ADDENDUM NO.: 01
PROJECT NAME: DUNNE TECHNOLOGY ACADEMY MODERNIZATION
PROJECT NO.: 05440
CONTRACT NO.: C1566
DATE OF ISSUE: February 27, 2015

NOTICE OF CHANGES, MODIFICATIONS, OR CLARIFICATIONS TO CONTRACT DOCUMENTS

PROJECT DUNNE TECHNOLOGY ACADEMY MODERNIZATION		TITLE REVISE NOTE 7, DETAIL #5	
FGM ARCHITECTS <small>CHICAGO OAK BROOK OFALLON ST. LOUIS</small>	DRAWN Author	DATE 02/26/2015	SHEET NO. CSK-001
	APPROVED Approver	JOB NO. 15-1950.01	ISSUED AS ADD #1
PROFESSIONAL DESIGN FIRM - IL # 184-000350

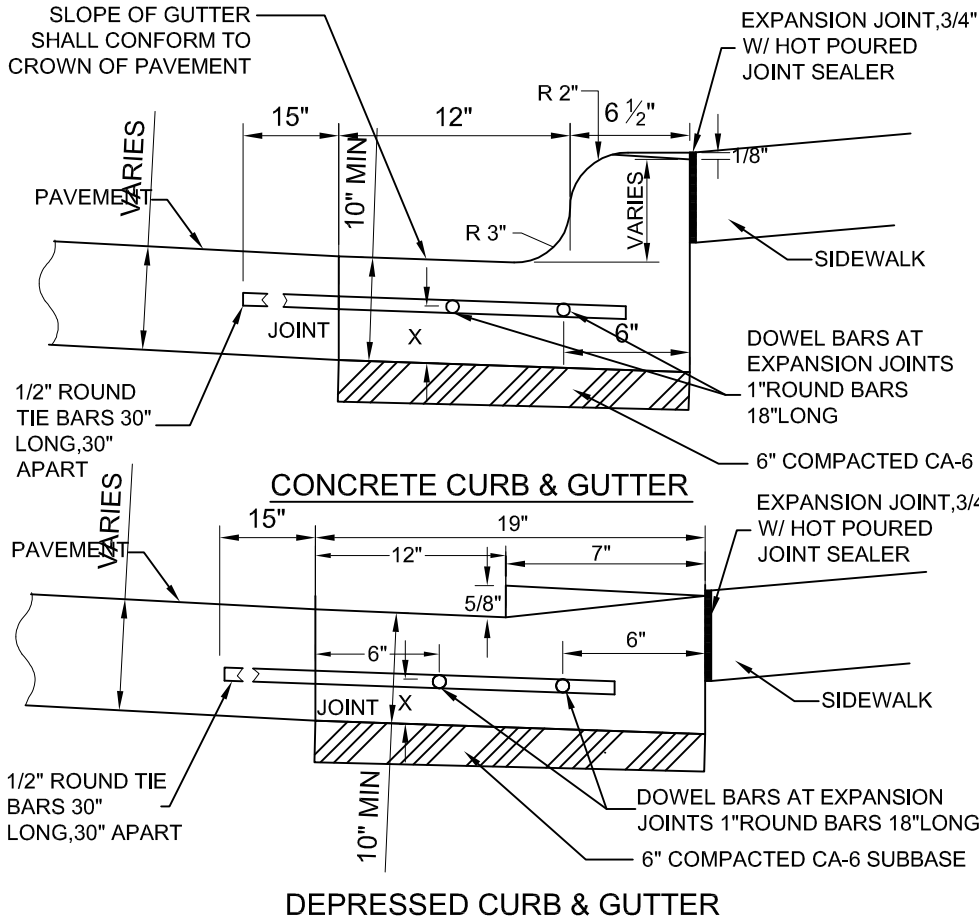
4. **Statement:** The ceiling grid in both the 1st and 2nd floor Corridors may need to be removed and replaced for the following reasons – please clarify:

- i. Visual inspection shows that when the building was constructed the acoustic ceilings were installed prior to the modular walls – see photo attached.

1. Drawing A6.1.0 shows the Main Corridor ceiling grid not lining up with the Classroom grid which differs from site conditions.
 2. In order to extend the walls to the deck the grid on both sides of the walls will have to be removed approx. 3’ on either side.

3. As the Corridor is only 10' wide this leaves a 4' strip down the middle which could be left in place. However, Drawing A6.1.0 shows the center row as 2x2 grid but my photo shows it is 2x4.

Response: Main Corridor existing ceiling grid on 1st and 2nd floors shall be removed and replaced. Grid shall be 2x4 to match existing ceiling grids in Existing Building.

PROJECT DUNNE TECHNOLOGY ACADEMY MODERNIZATION	TITLE KITCHEN CEILING DEMOLITION
---	----------------------------------

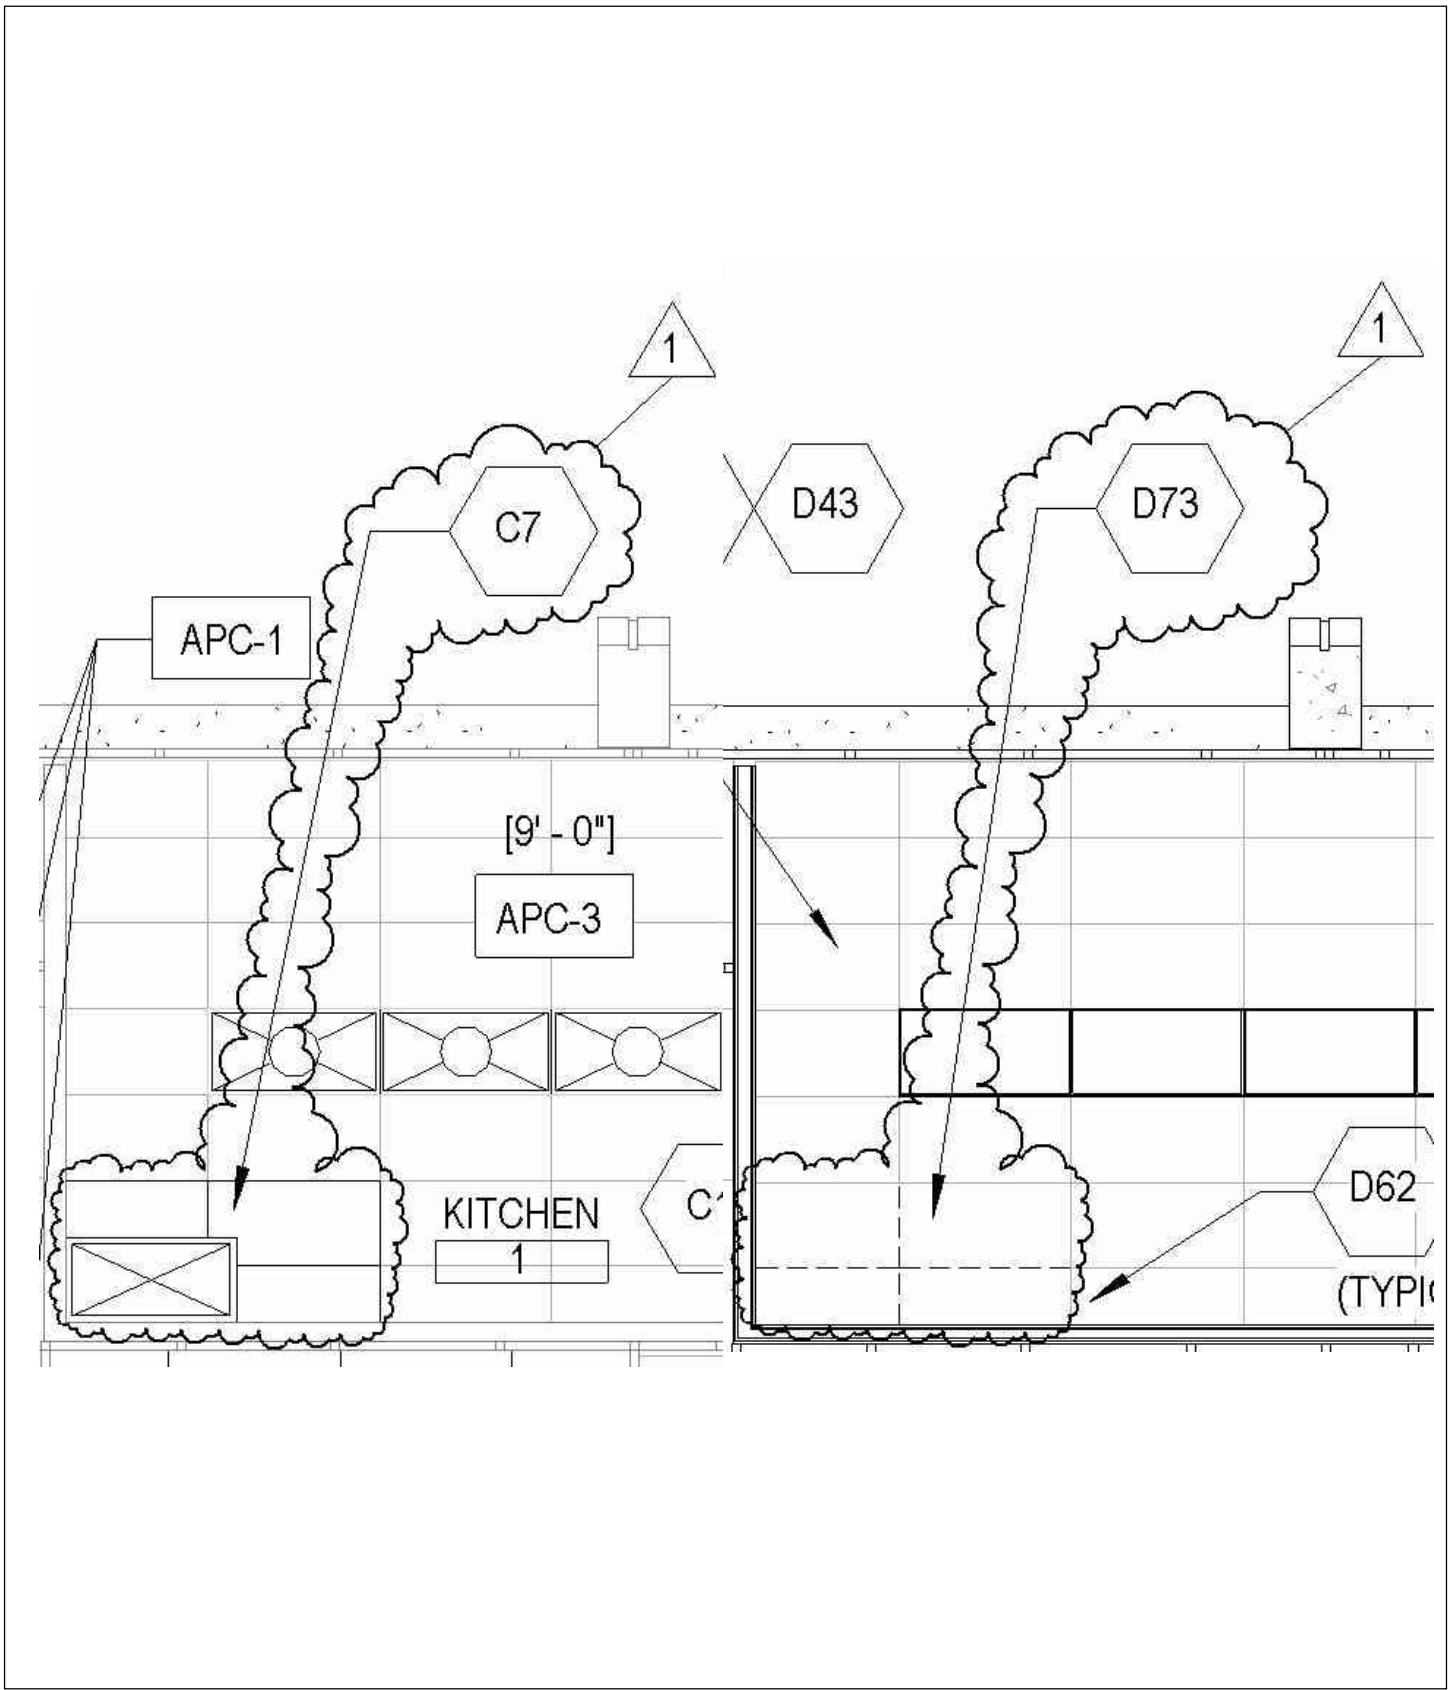
5. SHEET AD6.1.0 – DEMOLITION REFLECTED CEILING PLANS (Reference ASK-001)
 - a. Added Note D73 to read as follows: "REMOVE EXISTING SUSPENDED TILE AND GRID AS REQUIRED FOR INSTALLATION OF NEW KITCHEN HOOD. SEE M.E.P. DRAWINGS FOR PENETRATION DETAILS."

- b. Added Note D75 to read as follows: "REMOVE EXISTING SUSPENDED CEILING GRID AND TILES. SALVAGE EXISTING LIGHTING FIXTURES AND CEILING MOUNTED DEVICES FOR REINSTALLATION IN NEW CEILING."

H2 HEAD DETAIL

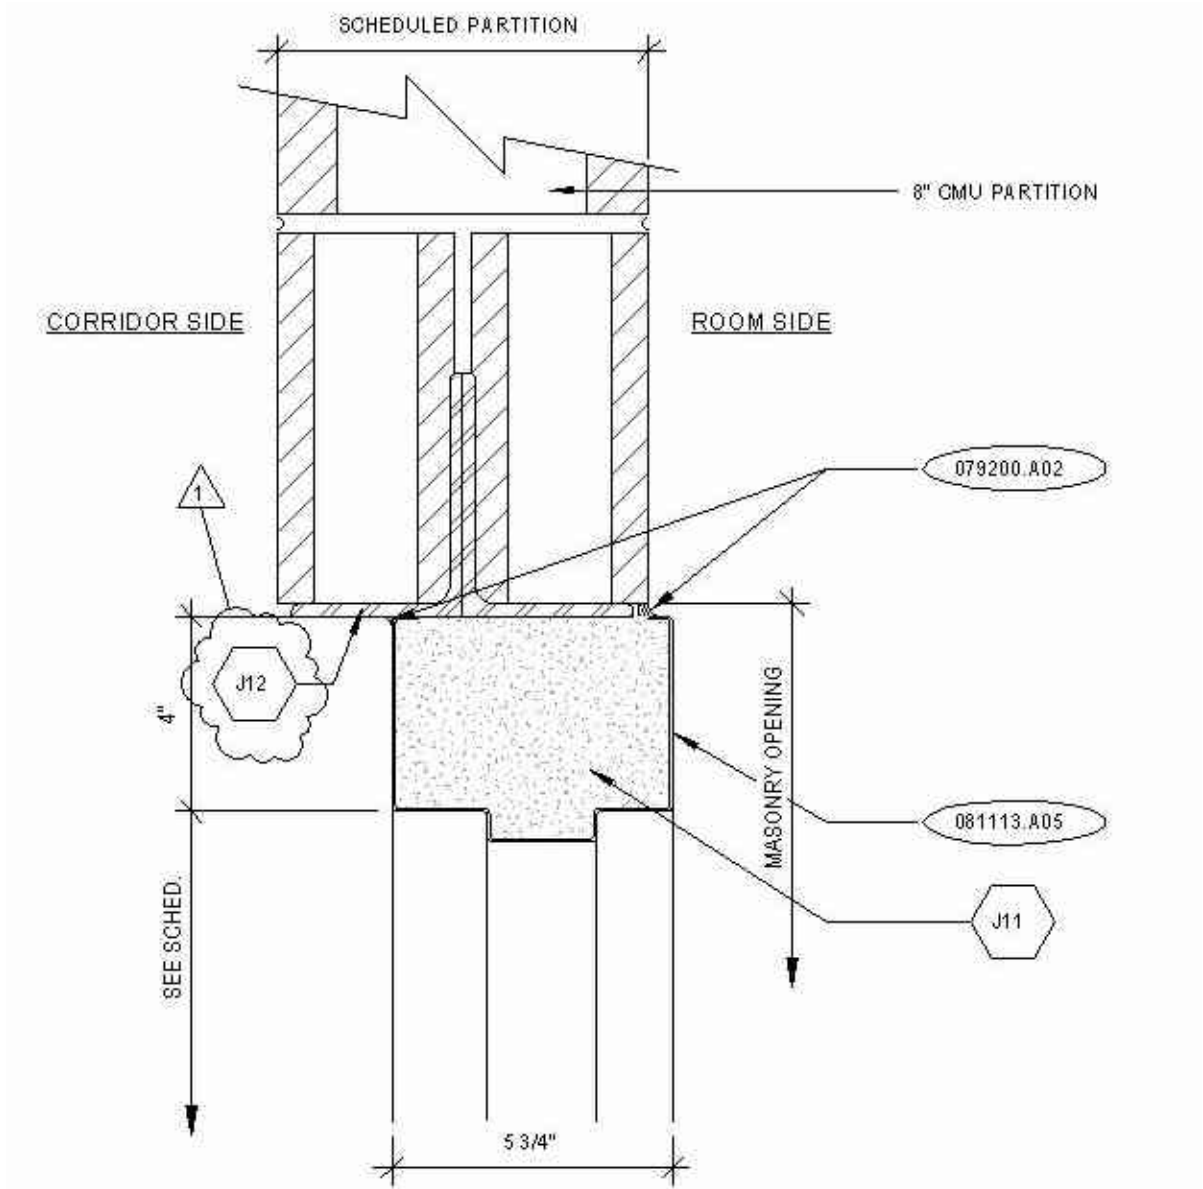
8. SHEET A2.3.0 – DOOR AND FRAME SCHEDULE, TYPES AND DETAILS (Reference ASK-002)
 - a. At Detail H2 add Note J12.
9. SHEET A6.1.0 – FIRST FLOOR REFLECTED CEILING PLAN (Reference ASK-001)

TITLE ADD INTUMESCENT PAINT TO ALL
LINTELS IN RATED PARTITIONS/WALLS

TITLE CEILING @ ELEVATOR LOBBY 251

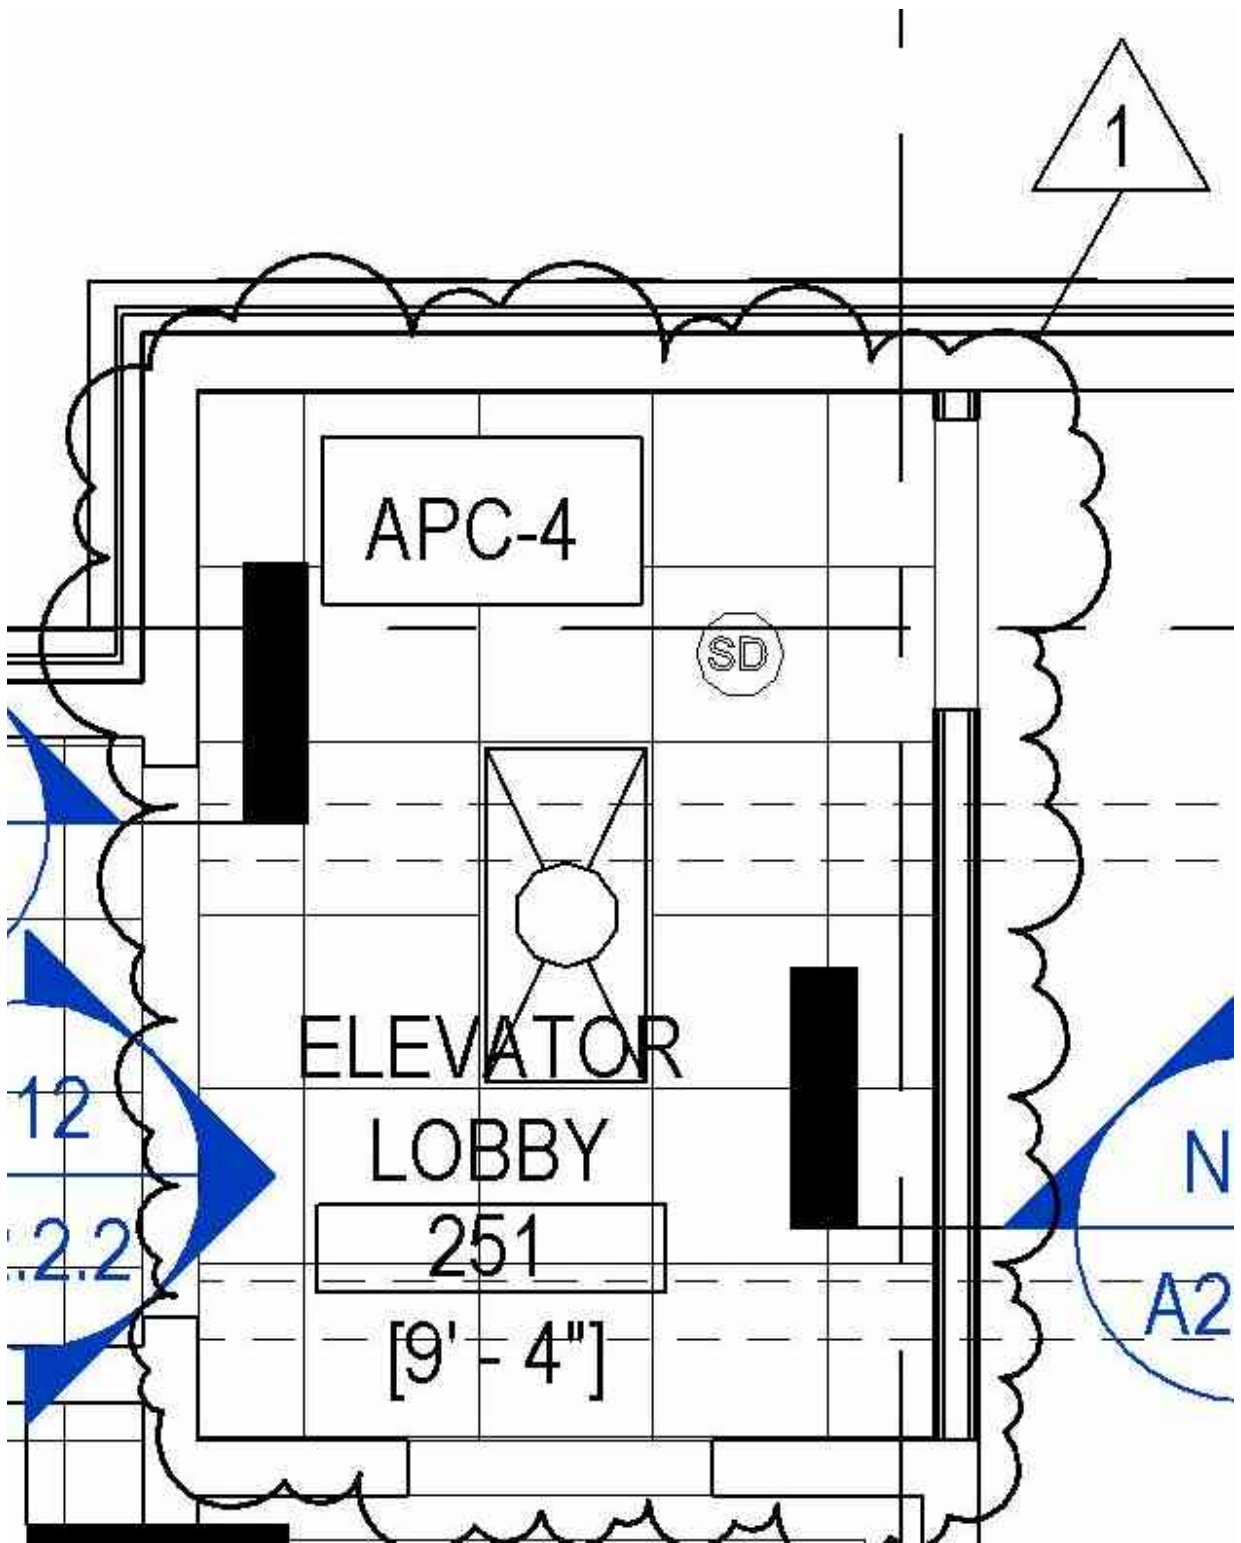
10. SHEET A6.2.0 – SECOND FLOOR REFLECTED CEILING PLAN (Reference ASK-003)
 - a. At Elevator Lobby 251 add APC-4 ceiling.
 - b. At Corridor 33 (including east-west section), add keynote "C5". New grid shall be 2'x4'.

TITLE FIRST FLOOR WALL COVERINGS

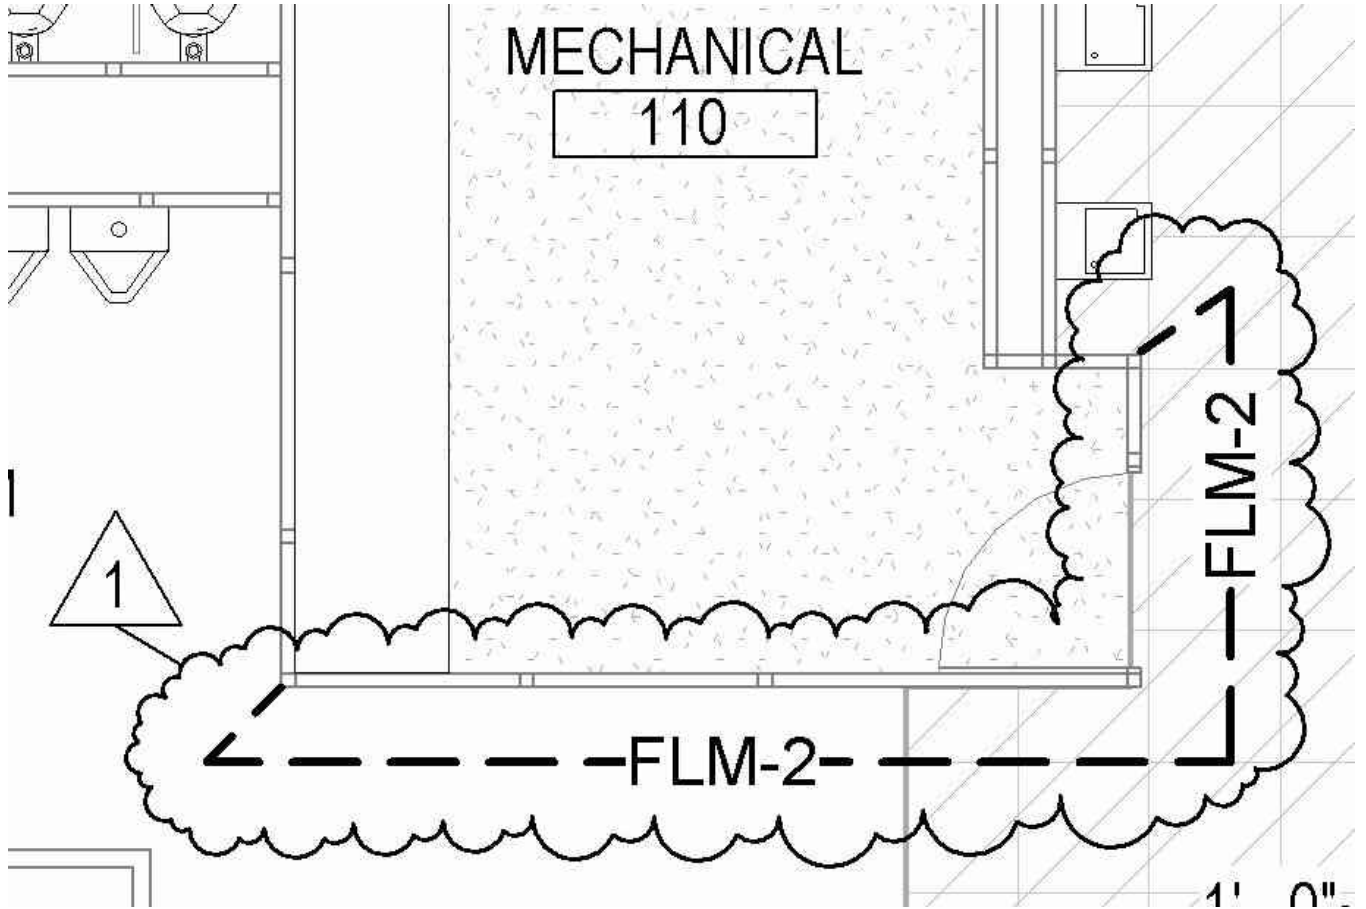
11. SHEET A8.1.0 – FIRST FLOOR FINISH PLAN
 - a. Revised extents of FLM-2. See Sketch ASK-004.
12. SHEET A8.2.0 – SECOND FLOOR FINISH PLAN
 - a. Revised extents of FLM-2. See Sketch ASK-005.
